510 Halsey Lane
Site
Improvements

11/01/16 CITY SUBMITTAL

LAYOUT PLAN

C2-1

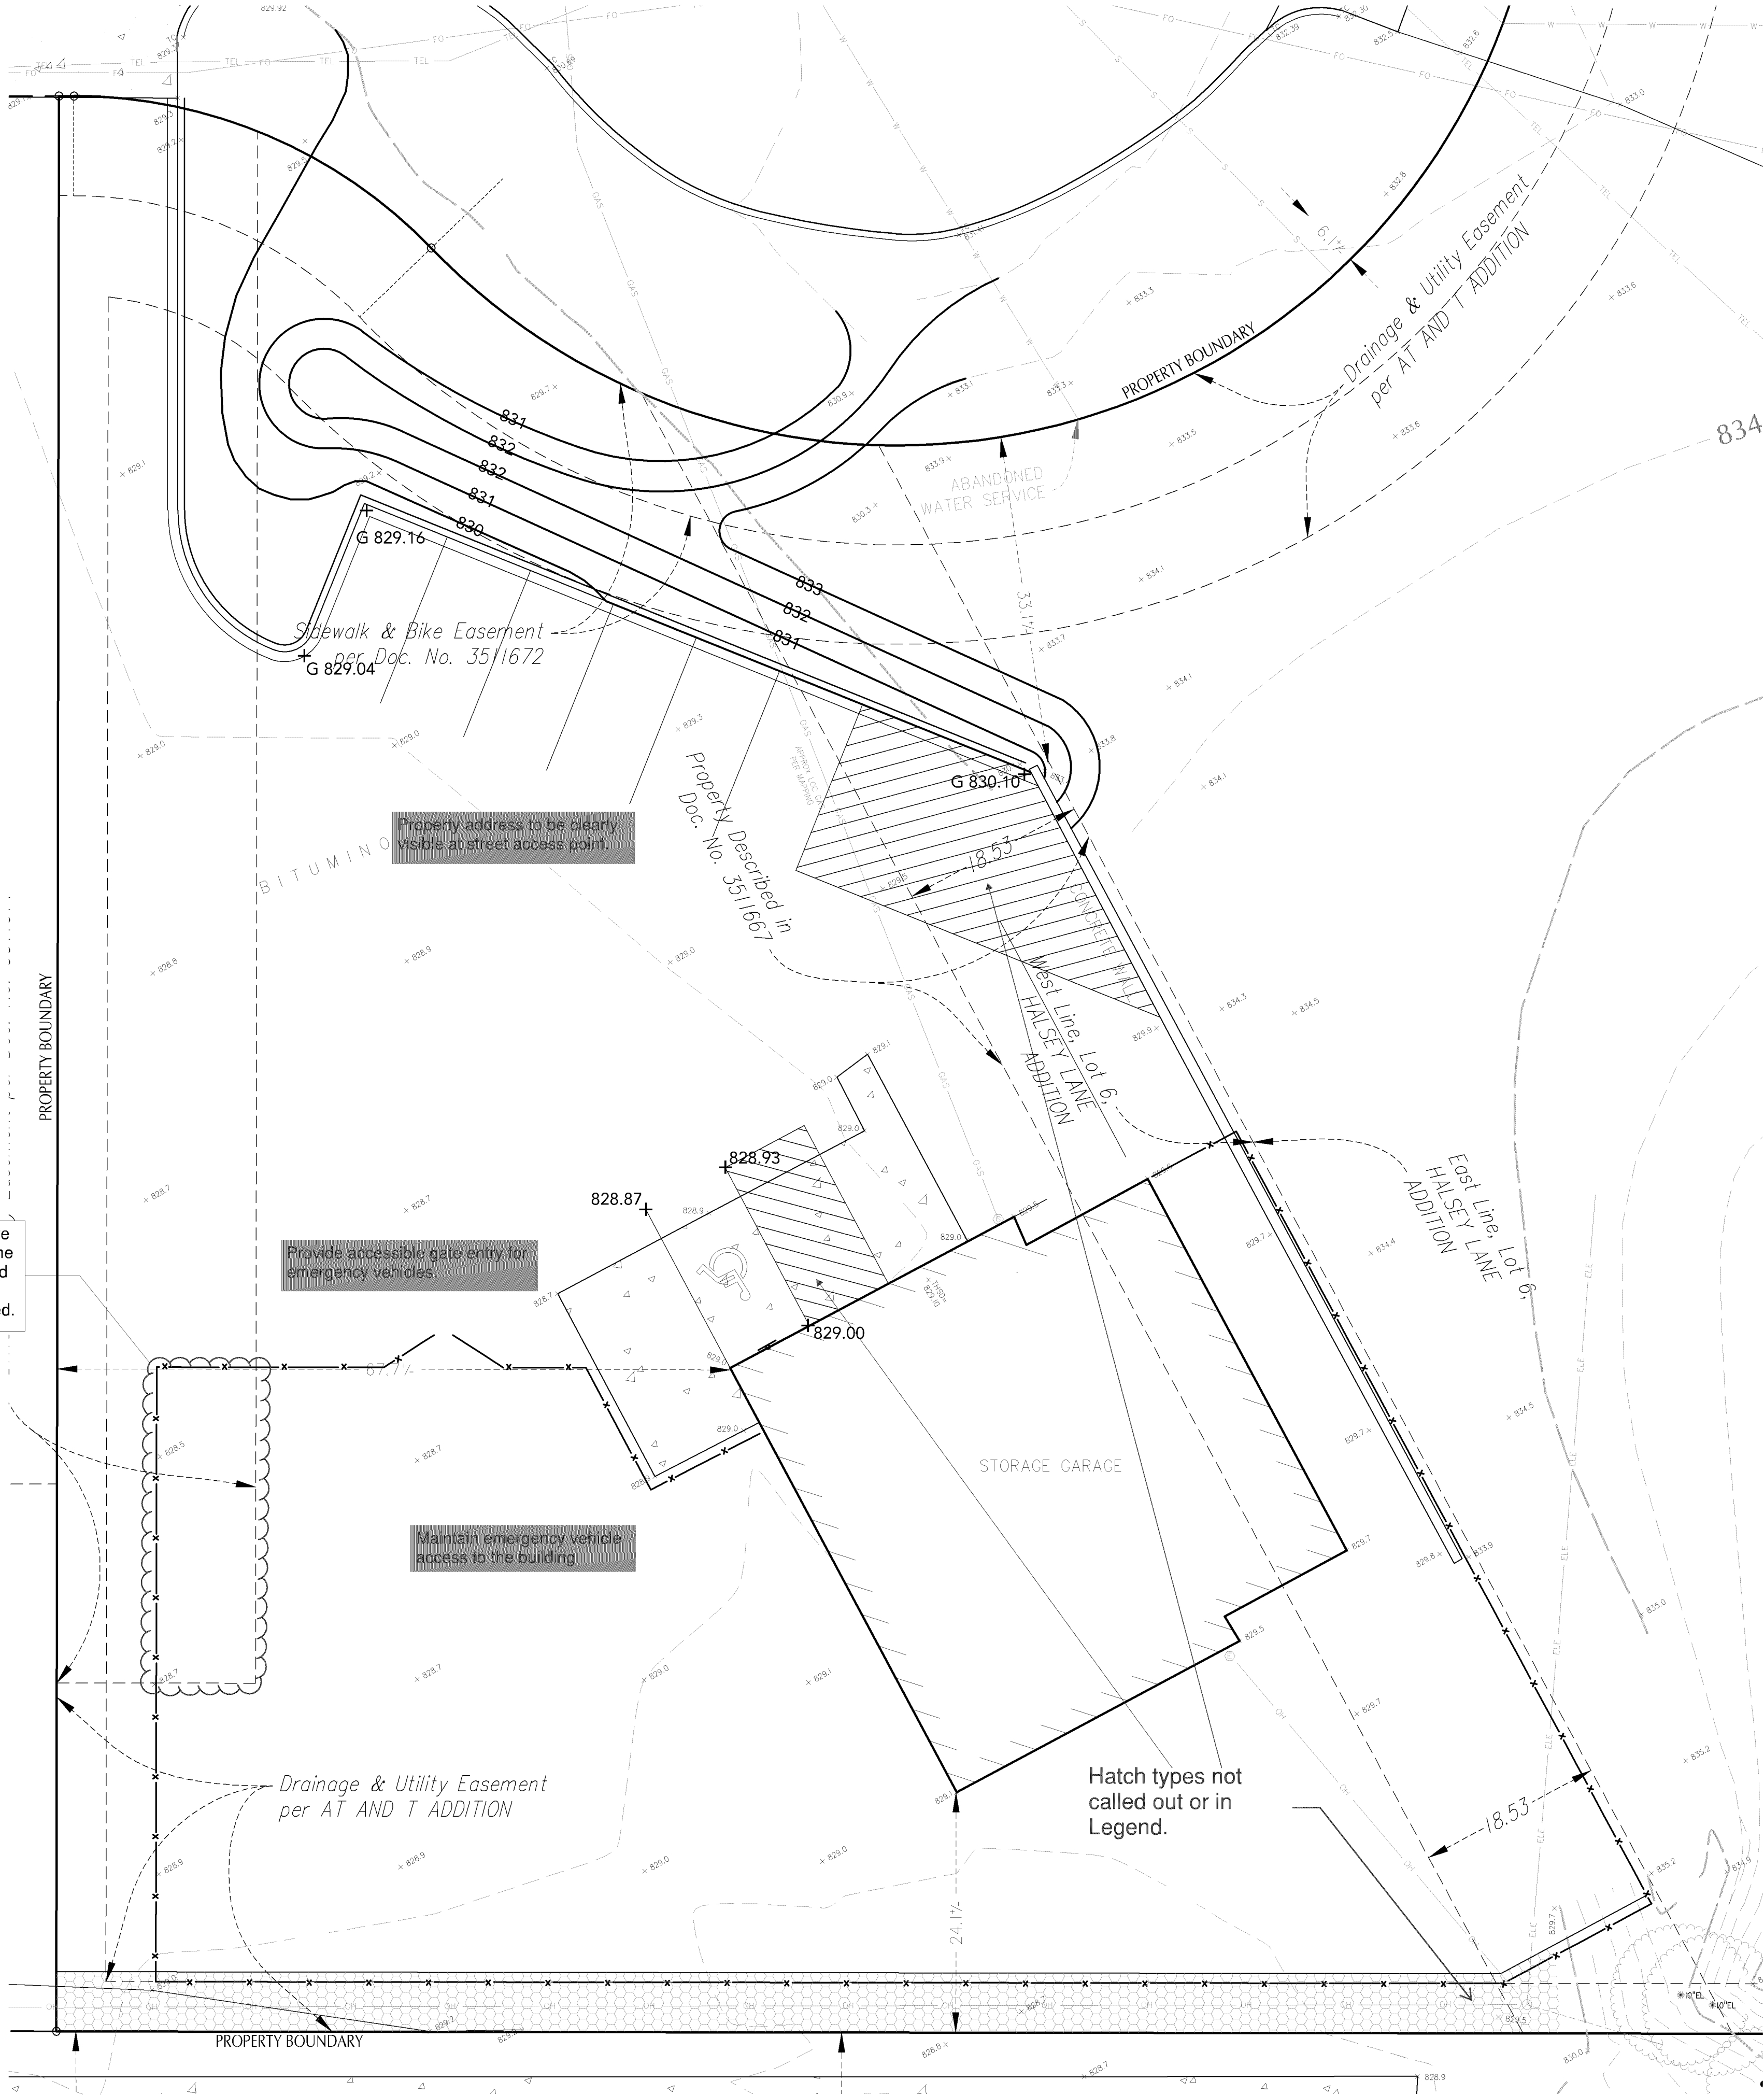
If the storage and fence are in the access easement, the property must be combined with the site to the west or easement must be modified.
